PROJECT: Indiana State University
Science South Elevator

PROJECT NUMBER: 12.035

ADDENDUM

Number: ONE

NBA-1

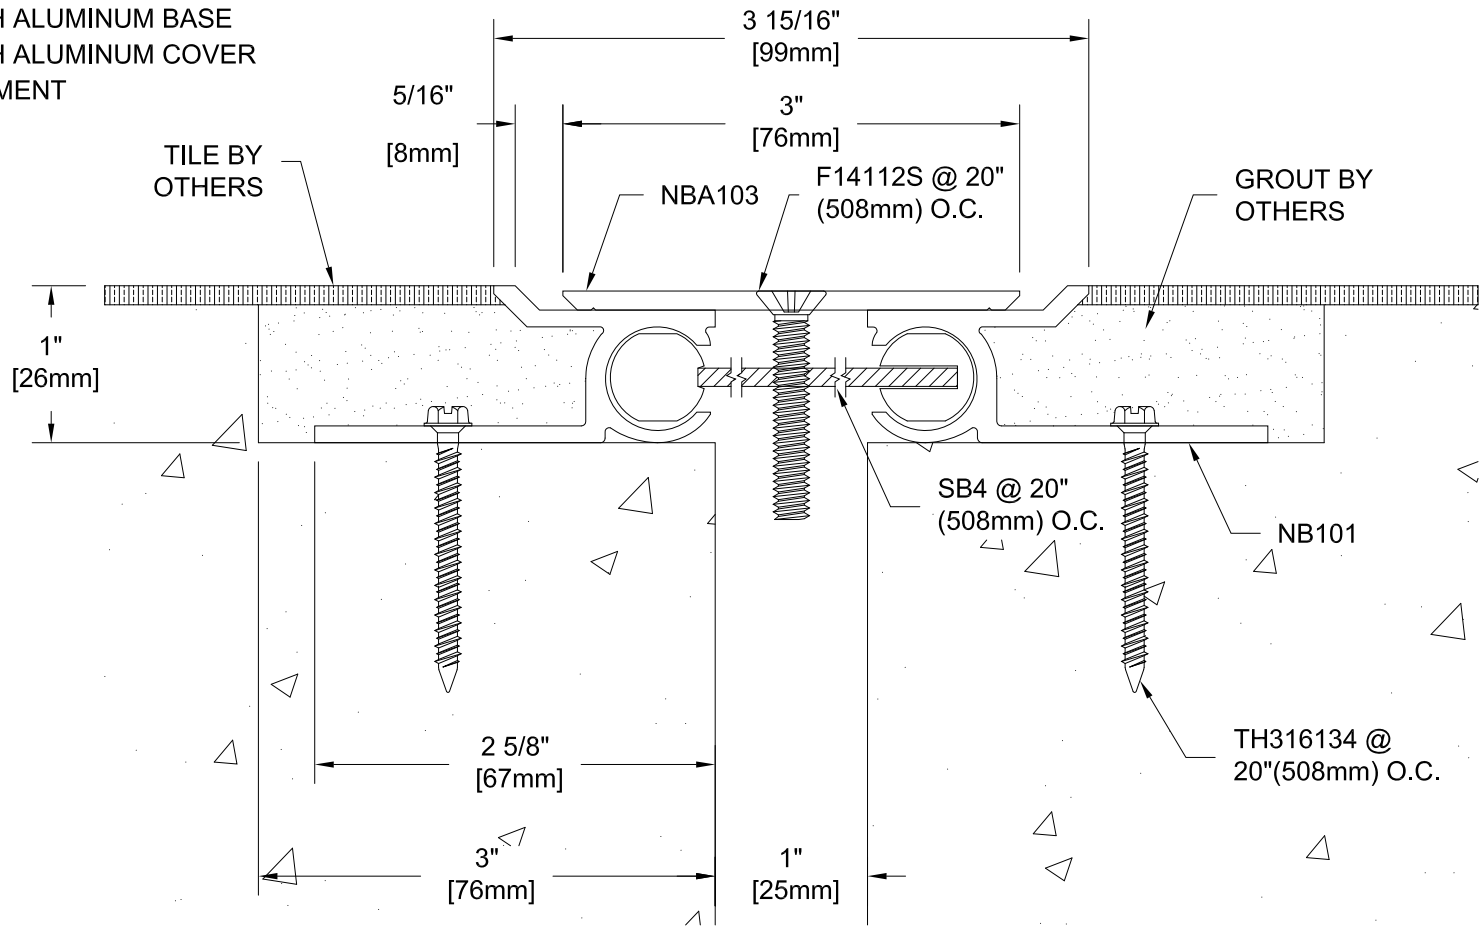
- 2.01 Expansion Joint Cover Spec.
- 2.02 095113 Suspended Acoustical Ceilings
- 2.03 081113 Hollow Metal Doors and Frames
- 2.04 Remove 089119 Louvers and Vents from Specs

Q7. What is the spec. and material of the expansion joint cover?

NO-BUMP FLOOR TO FLOOR SYSTEM
 MILL FINISH ALUMINUM BASE
 MILL FINISH ALUMINUM COVER
 50% MOVEMENT
